**MUNICIPAL CORPORATION
KARACHI.**

PLAN SHOWING ADDITION & ALTERATION TO BUILDING ON PLOT NO. 27. R.S.2. RAMSWAMI QR.

With reference to your application dated 18-8-38 recd. on 20-8-38
with a plan for the proposed buildings/additions and alterations on plot
No. 27 Survey Sheet No. R.S. 2, Ramswamy Quarter,
I have to request you to comply with the following requirements:—

With reference to your application dated 30-6-38 recd. on 1-7-38 with a plan for the proposed buildings/additions and alterations on plot No. 27 Survey Sheet No. R. 3. 2, Ramswamy Quarter, I have to request you to comply with the following requirements:—

PLAN SHOWING ADDITION
& ALTERATION TO BUILDING
ON PLOT No. 27. R.S. 2,
RAMSWAMI QR.

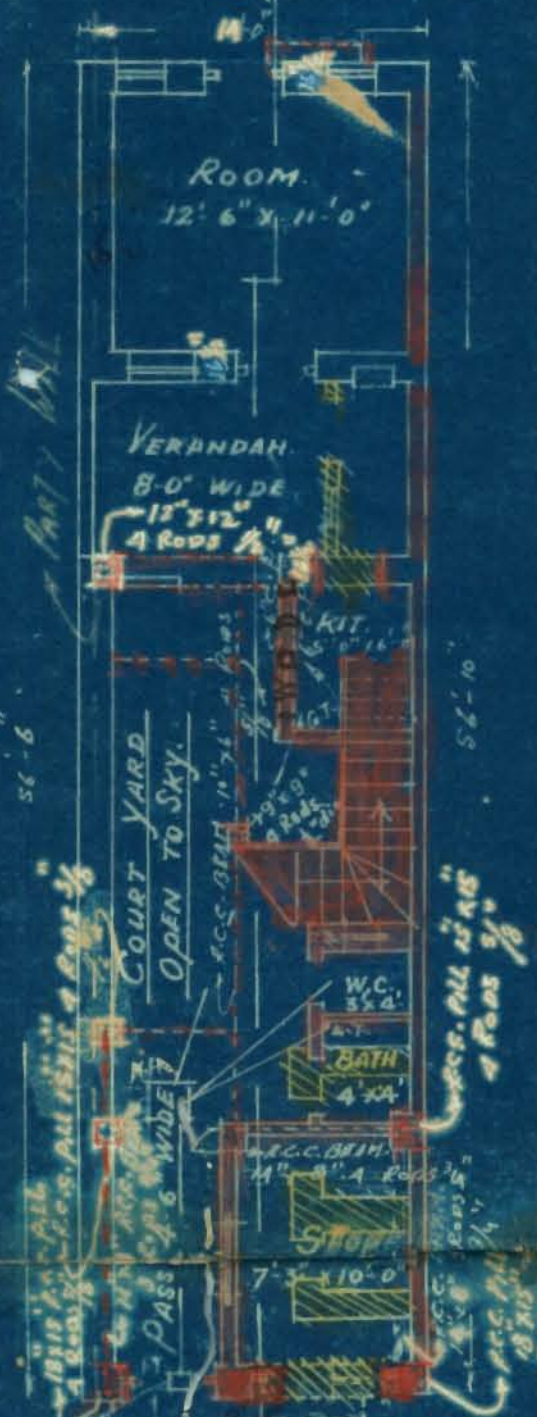
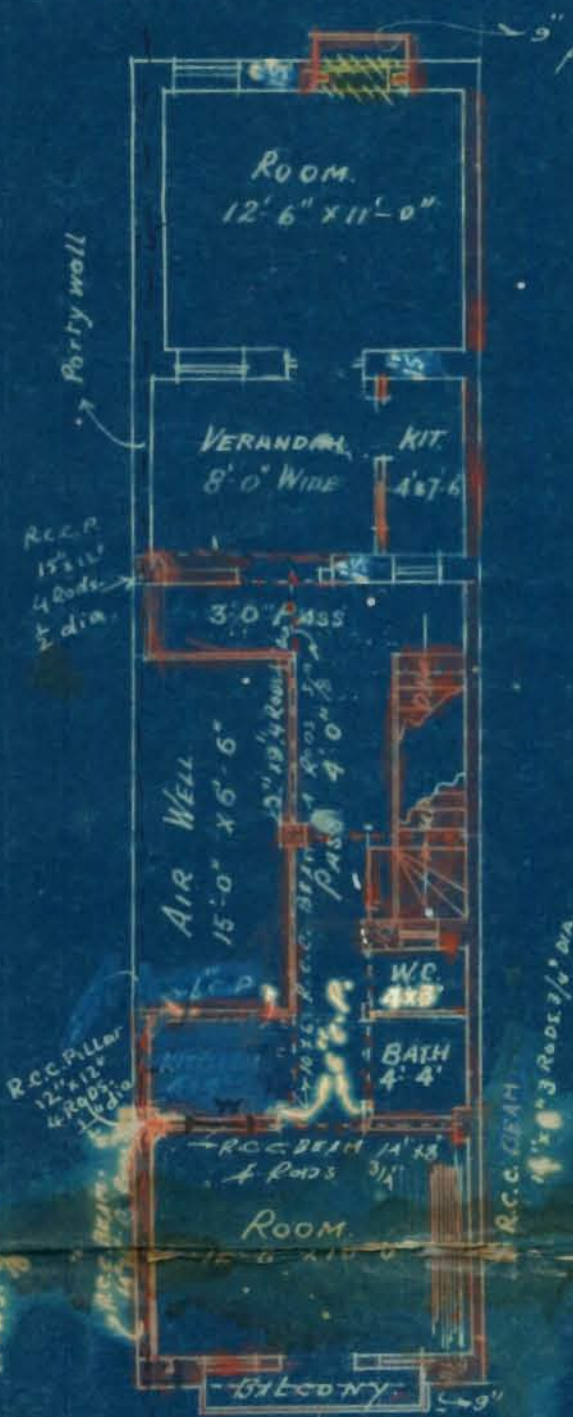
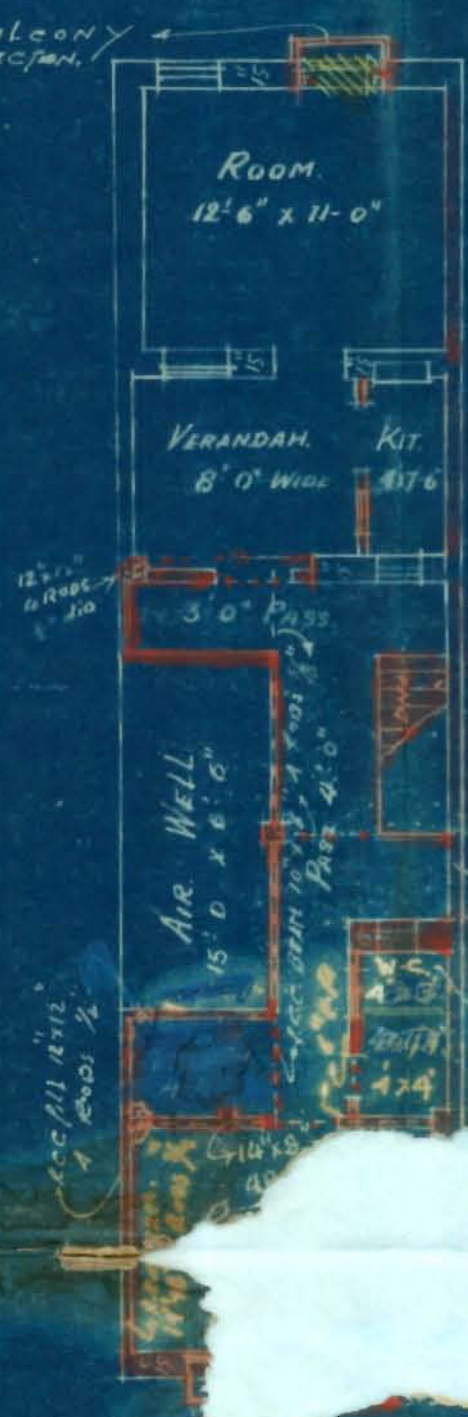
Either the land available for grant be purchased or
proposed 9" balconies be deleted.

9) The architect is requested
 to see the BS in connection
 with calculations for
 front masonry pillars
 4.4 tons/sq is too
 much for Kupsch pillars

Either the land available
 for grant be purchased or
 proposed 9' balconies be
 deleted.

Complied with
- to - 1) Thickness of existing walls still require correction
2) Party wall lines shall be shown on upper floor plans
3) Kitchen under stairs reply of architect be please perused
4) Complied with by providing Rec pillars to relieve load from
the wall.
5) not complied with Requirement no 8 of 22/38 is not complied with
6) Complied with
7) L.M.A's orders as per L.S. report of 26/8/36

With reference to your No. 235/38 of
14th September 1938, we beg to inform
you that the 9" balcony shown in
existing structure on the 1st & 2nd
floor facing the Rangoon Street is
now deleted.

Submitted
The balconies over
the land available for grant are
now deleted from the plan. There
is no objection now.

Since
 Rec
 pillars
 are provided
 at the end
 this will do.

PLAN SHOWING ADDITION
& ALTERATION TO BUILDING
ON PLOT No. 27. R.S. 2,
RAMSWAMI QR.

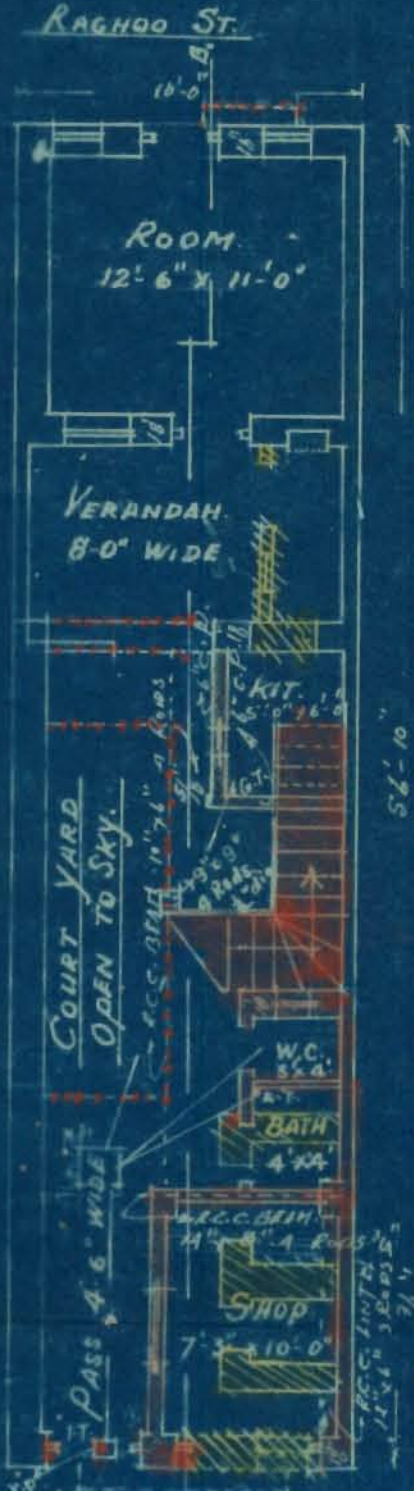
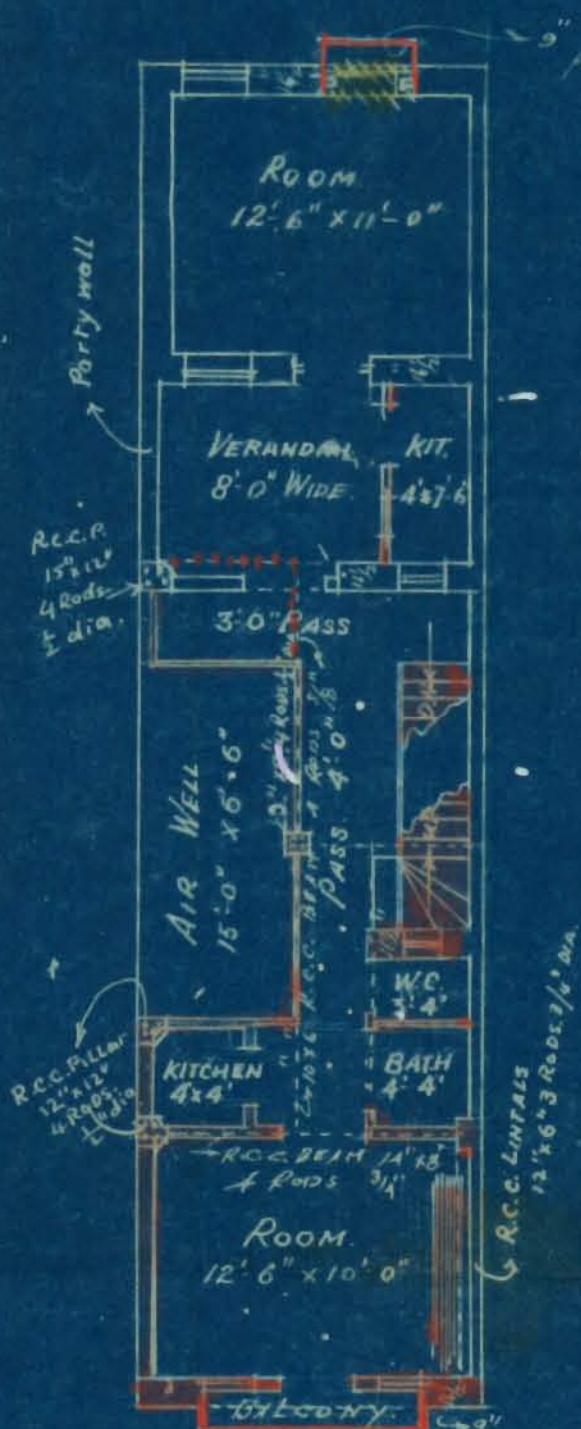
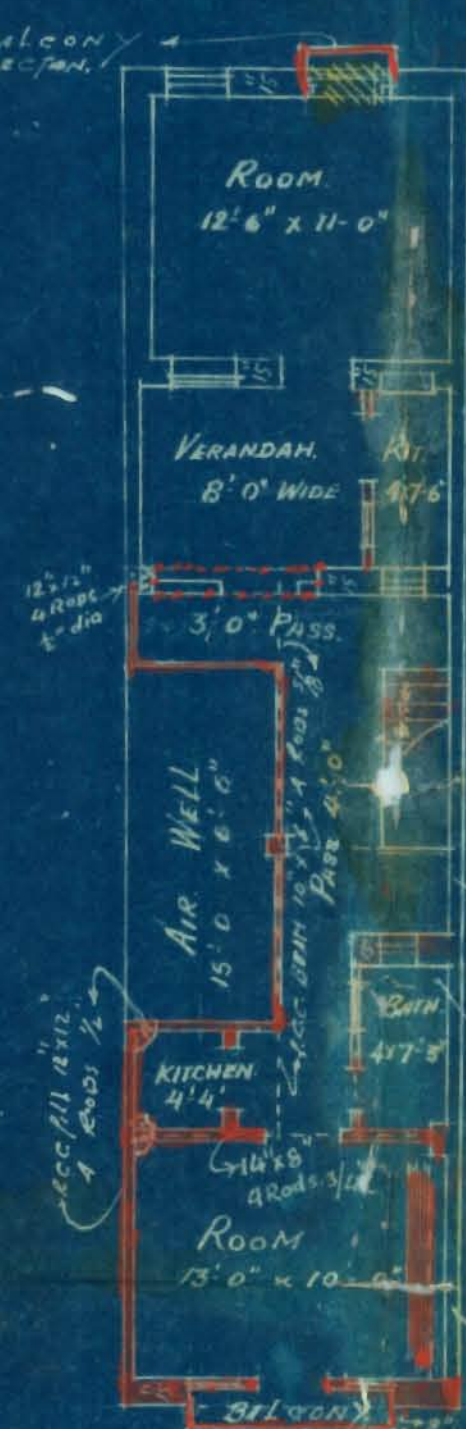
H.O.'s objection.

1. One room tenement objected.

L.S.'s objections.

2. Width of Roads to be shown.

3. Alignment line to be shown & the land available for grant be purchased.

L.M.'s objections.

4. Thickness of walls shown in plan is not as per site. 15" walls from G.F. new structures will not do.

5. Though letter is produced for party wall on the west, the same is not shown in the plan.

6. Kitchen under ~~xxxxx~~ stairs will be dark.

7. Foundation for the existing internal & party wall be exposed for inspection.

8. Thickness of party wall be given.

9. W.C. on the 2nd floor be provided.

10. Land available for grant requires to be purchased.

11. Shop less than 100 sq.ft. can not be allowed.

12. Calculations for R.C.C. work be given.

13. Load calculations... ~~for R.C.C.~~ pillars be given.

14. W.C. on 1st floor below Bath on 2nd floor will require

15. Thin external wall must be 6" C.P.

- ✓ (1). We are herewith submitting the attached letter in support of H.O's objection No.1 that is single room tenement can be allowed etc. & request that you will very kindly reconsider the same as the room is provided with separate Kit., Bath & w.c..

- ✓ (2). Complied.
- ✓ (3). Complied.
- ✓ (4). Thickness now corrected as per site of the existing structure.
- ✓ (5). Complied.
- ✓ (6). Kitchen under staircase is well provided with windows & hence there will be sufficient light.

- ✓ (7). We have now thought to carry the R.C.C. pillars in the part wall as the foundation of the same is only 2' wide & 3' deep.
- ✓ (8). Complied.
- ✓ (9). Complied.

- ✓ (10). We are not building any new structure on the Raghoo street where there is alignment & hence it is not necessary to purchase the same *at present.*

- ✓ (11). The proposed small room on the ground floor by the side of the passage will be used as a store room & request that the same may be approved..

- (12). Submitted herewith.
- (13). do.
- (14). Now provided as per 1st floor arrangement.
- (15). All external wall ^{are provided} 6" thick please.
